From: Stephanie Meadows
Sent: Thursday, October 17, 2013 3:00 PM
To: Hanlon, Edward
Subject: Submission of Materials for Consideration by the Hydraulic Fracturing Research Advisory Panel for its November 20, 2013 Teleconference

Re: Comments of the American Petroleum Institute on EPA's Notice of Extension of the Public Comment Period of the draft Research Report titled, "Investigations of Ground Water Contamination near Pavillion, Wyoming." (78 Federal Register 2396) – Docket ID No. EPA-HQ-ORD-2011-0895

2.1 Failure to follow EPA'S approved Work Plan⁵ in monitoring well design and construction

Figure 2. Graph of pH and specific conductance readings taken during low-flow sampling of MW-01 by EPA during Phase III (October 6, 2010).

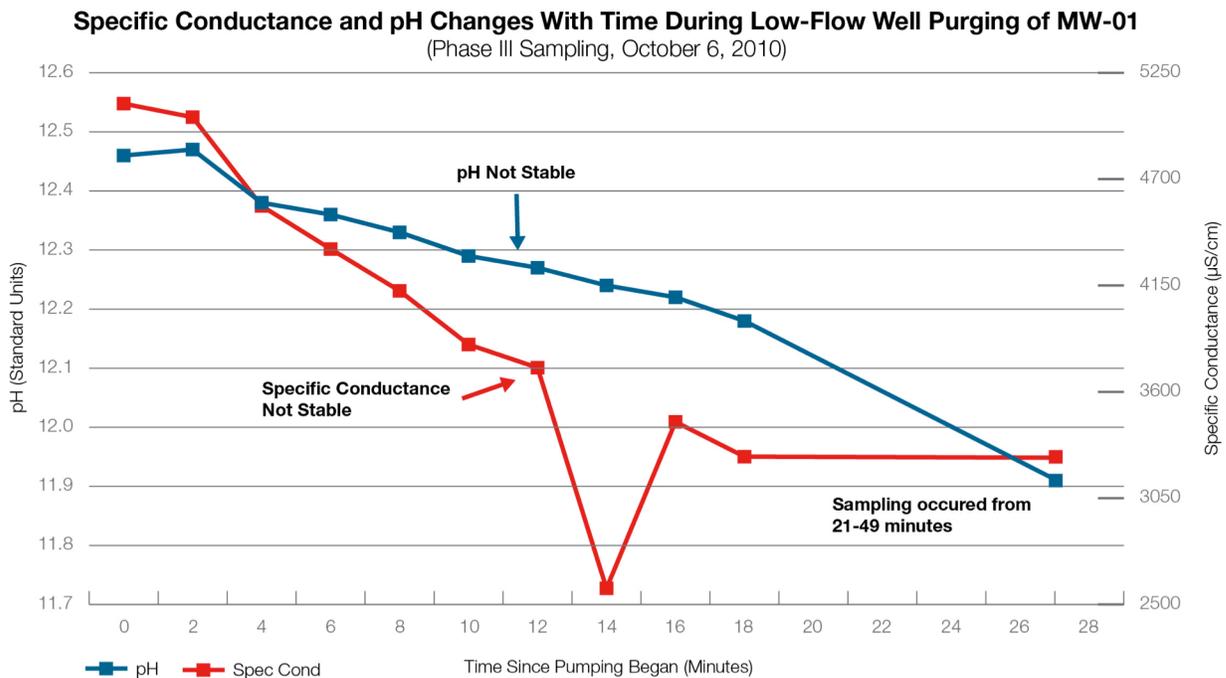
Data provided in **Tables 2 and 3** clearly and concisely show that the pH, oxidation-reduction potential, and specific conductance were not stable in well MW-01 during either of the Phase III or Phase IV sampling events, contrary to EPA’s statement noted earlier on page 20 of their Draft Report¹. **Figures 2 and 3** are plots of the pH and the specific conductance data from MW-01 during these Phase III and IV sampling events, respectively, and show the pH and specific conductance instability.

Figure 4. Graph of pH and specific conductance readings taken during low-flow sampling of MW-02 by EPA during Phase III (October 6, 2010).

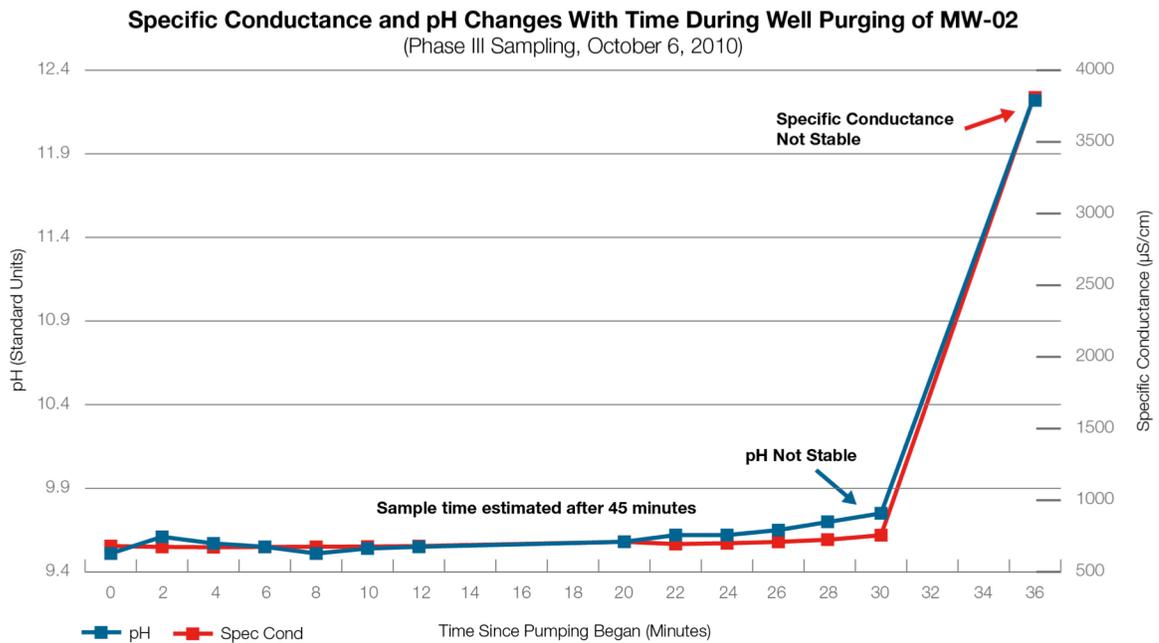
During Phase III sampling of well MW-02, a major change in pH, oxidation-reduction potential, and specific conductance occurred between 30 to 36 minutes into the low-flow pumping period. EPA does not point out this change or discuss possible reasons for the dramatic increase in pH and specific conductance (decrease in oxidation-reduction potential) in MW-02, consistent with cement contamination. Likewise, EPA fails to discuss or point out the lack of stability in the pH, oxidation-reduction potential, and specific conductance during sampling of MW-01 during both Phase III and Phase IV sampling events. The low pH between 9.3 to 9.8 and low specific conductance in monitoring well MW-02 may be due to imported water added and left in the monitoring well during development on September 11, 2010.

Figure 5. Graphs of oxidation-reduction potential from low-flow sampling data from monitoring wells MW-01 and MW-02 during the Phase III and IV sampling events.

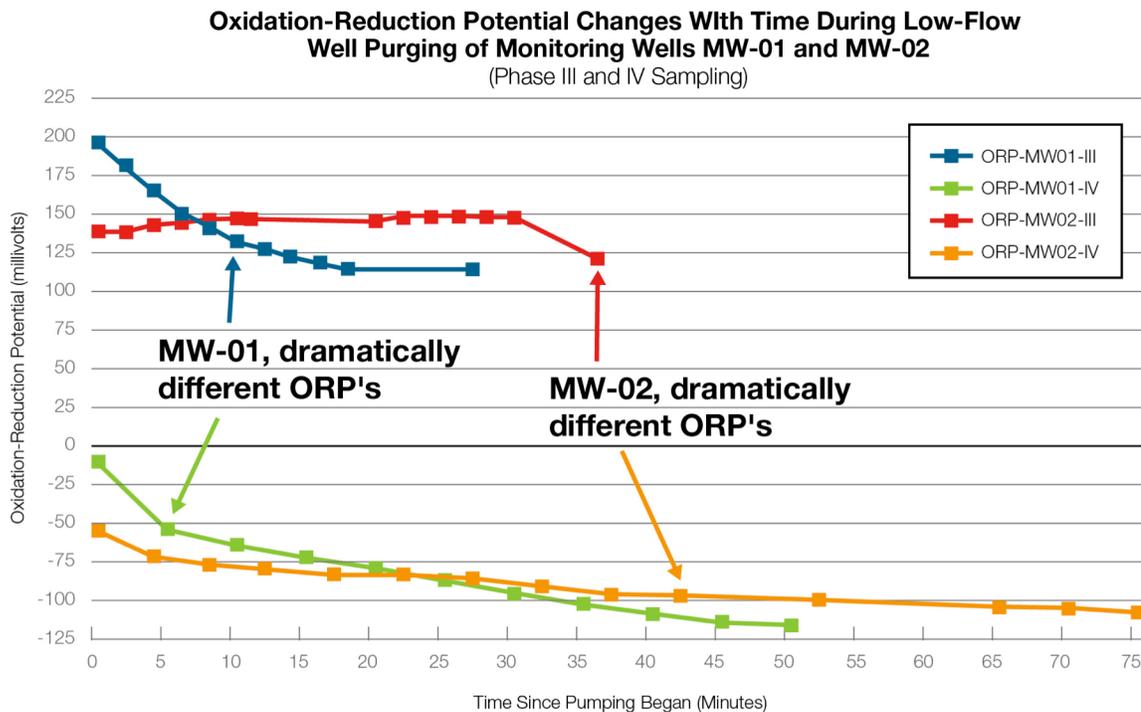
Figure 5 is a graph of the oxidation-reduction potential (ORP) measured in groundwater from monitoring wells MW-01 and MW-02 during the Phase III and IV sampling events. These graphs also show that the ORP was unstable during the low-flow sampling events. **Figure 5** also shows that there is a large discrepancy between the ORP measured in each well between the Phase III and Phase IV sampling events. For example, the ORP measured in monitoring well MW-01 during the Phase III sampling event on October 6, 2010 ranged from 114.3 millivolts (mV) to 196.4 mV. During the Phase IV (April 20, 2011) sampling event, the ORP in this same monitoring well ranged from -10.2 mV to -116.2 mV. A similar discrepancy occurs in the ORP reading from monitoring well MW-02. EPA fails to discuss how such a large difference in ORP readings can occur in groundwater from the same well.

EPA WELL CONSTRUCTION DETAILS

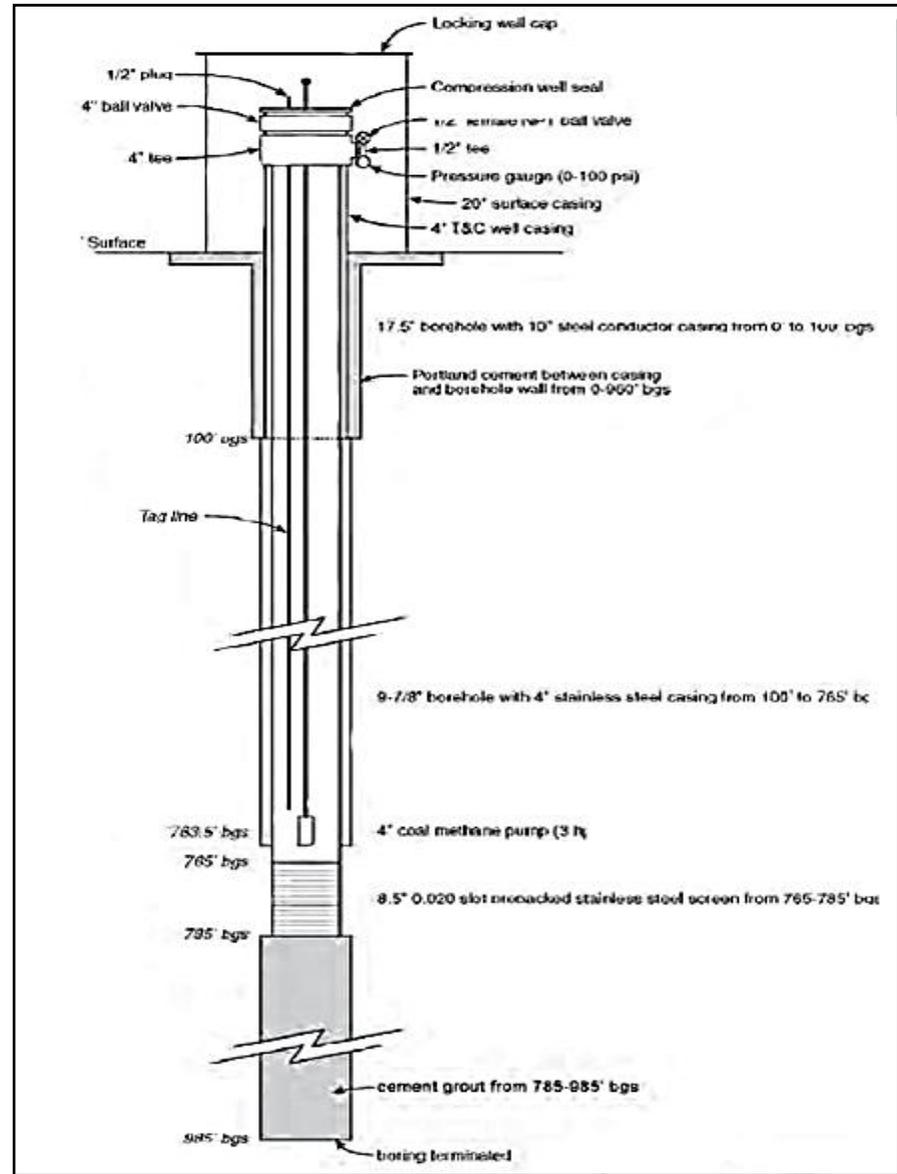
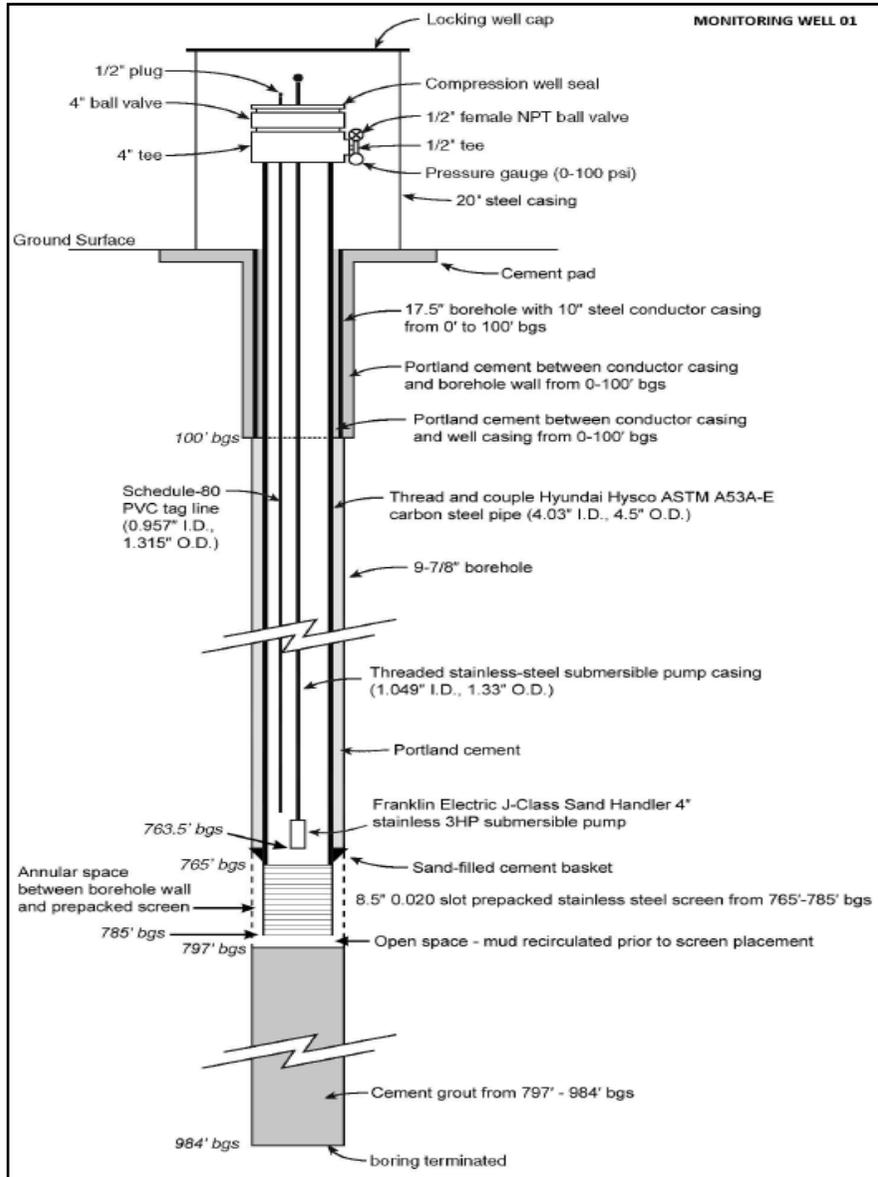
EPA's on-site contract geologist reported that the top of the cement grout used as backfill below the well screen in MW-01 was at 797 feet bgl. This is in disagreement with the 785 feet bgl reported on figure 6a of EPA's December 2011 Draft Pavillion Report¹, a difference of 12 feet. In addition, the interval from 785 bgl (bottom of screen) and the top of the cement grout at 797 feet bgl as reported by EPA's on-site contract geologist was open and not filled with anything but drilling fluids/mud. This cement can also leach associated chemicals into the well screen interval.

On figure 6a, this interval (785 to 797 feet bgl) is inaccurately and incorrectly shown by EPA as being filled with cement grout. The fact that nothing was present other than drilling fluids in the borehole interval from 785 feet bgl to 797 feet bgl in MW-01 would increase the possibility of cement grout invading this open-hole interval and the well screen interval directly above. It would be virtually impossible to fully remove the drilling fluids left in this open interval through well development. Therefore, these fluids are almost certainly in contact with the well screen in well MW-01, along with cement.

Examination of the photographs provided in EPA's December 2011 Draft Pavillion Report¹ and **Figure 1** show the sand basket painted blue, approximately 1.8 feet long, possibly rubber/plastic lined, and welded to the top of the stainless steel well screen. A painted sand basket is not shown on figure 6a of EPA's Draft Report¹.

EPA's on-site contract geologist well construction diagram¹⁸ shows centralizers were used at two locations on the riser pipe in MW-01 (none are being shown as used in MW-02), but no depths are provided. The centralizers are not reported or shown on figure 6a, (or on the November 6, 2012 revised well construction diagrams for MW-01) nor are they discussed in the field notes maintained by the on-site geologist or the driller, and their use is not described in EPA's December 2011 Draft Pavillion Report¹.

The well construction diagram (figure 6a) for MW-01 provided in the December 2011 Draft Pavillion Report¹ incorrectly indicates nothing but open space in the annular space between the 10-inch steel conductor surface casing set to 100 feet bgl and the 4-inch carbon steel casing, however, on the November 6, 2012 revised well construction diagram¹³, this annular interval is shown to be filled with Portland cement. The new well construction diagram¹³ for well MW-01 posted by EPA on November 6, 2012 also correctly shows that there is an open annular space between the borehole wall (9-7/8 inches) and the 20-foot long 8.5-inch pre-packed well screen, an open annular space of approximately 1-3/8 inches which, if evenly distributed, would surround the pre-packed well screen and borehole wall filled with nothing but fluids over this 20-foot interval. The fact that nothing was present other than fluids in this 20-foot borehole interval from 765 feet bgl to 785 feet bgl in MW-01 increases the probability that cement grout invaded this open-hole interval between the pre-packed sand pack and borehole wall. None of the

well construction diagrams for MW-01 indicate that powdered bentonite was added to the cement as required by the Work Plan⁵, but rather, all construction diagrams for MW-01 indicate **“Portland cement”** was used.

Many of the inaccuracies and discrepancies highlighted above have been corrected on the newly posted (November 6, 2012) well construction diagram¹³ for MW-01 on EPA’s Pavillion website¹². However, the new diagram¹³ still does not show or disclose that painted/coated carbon steel casing or riser pipe (as first reported by USGS) and a painted sand basket (with some sort of black liner) was used down hole. Finally, it is very unlikely that previous peer reviewers are aware of these significant changes.

MW-02

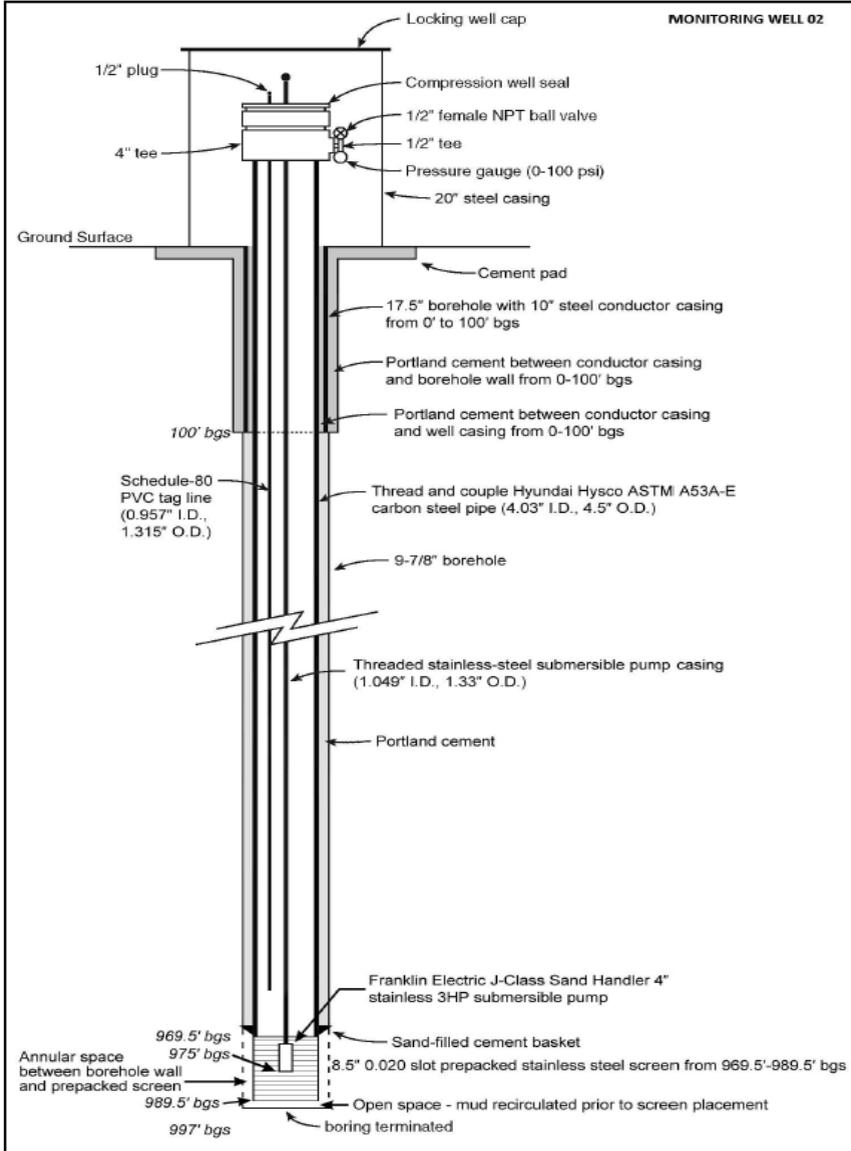
Monitoring well MW-02 construction diagram provided in the Draft Report¹ (besides EPA’s similar incorrect statements regarding use of the stainless-steel riser pipe versus what was actually used black painted/coated carbon steel), does not show the 1.8 foot long blue-painted (possibly black rubber or plastic lined) sand basket welded to the top of the well screen. No centralizers are shown on the on-site geologist field construction diagram¹⁹ on figure 6b, or on the newly-revised (November 6, 2012) well construction diagram¹⁴. The well construction drawing (figure 6b) for MW-02 in the December 2011 Draft Pavillion Report¹ incorrectly indicates nothing but open space in the annular space between the 10-inch steel conductor surface casing set to 100 feet bgl and the 4-inch carbon steel casing. However, on the November 6, 2012 revised well construction diagram¹⁴, this annular interval is shown filled with Portland cement. None of the well construction diagrams for MW-02 indicate that powdered bentonite was added to the cement as required by the Work Plan⁵, but rather, all construction diagrams for MW-02 indicate only **“Portland cement”** was used.

There also appears to be a discrepancy in the screen placement interval. The on-site field geologist construction diagram¹⁹ shows the depth of screen placement to be 960 to 980 feet bgl as does the well construction diagram provided as figure 6b in EPA’s December 2011 Draft Pavillion Report¹. However, additional work conducted by USGS in 2012 reported a discrepancy in this well’s depth during down hole camera work. The revised well construction diagram¹⁴ for MW-02 posted on EPA’s Pavillion website¹² on November 6, 2012 show that the screen intervals has been revised downward by 9.5 feet, or the screen is now reported to occur from 969.5 feet bgl to 989.5 feet bgl. Open hole exists below the screen (screen bottom at 989.5 feet bgl) to 997 feet bgl (a distance of 7.5 feet) where the hole may be filled with drilling mud and/or cuttings.

The well construction diagram, for MW-02 provided in the December 2011 Draft Pavillion Report¹ and the on-site field geologist field diagram¹⁹ reports the open hole interval below the screen to be filled with **“cuttings and mud fill”** materials, but the newly revised November 6, 2012 diagram¹⁴ inexplicably states that that this material is now **“mud recirculated prior to screen placement.”** It would be virtually impossible to fully remove the drilling fluids left in this open interval through well development. Therefore, these fluids are almost certainly in contact with the well screen in well MW-01, along with cement.

Many of the inaccuracies and discrepancies highlighted above have been corrected on the newly posted (November 6, 2012) well construction diagram¹⁴ for MW-02 on EPA’s Pavillion website¹². However, the new diagram¹⁴ still does not show or disclose that painted/coated carbon steel casing (as first reported by USGS) and a painted sand
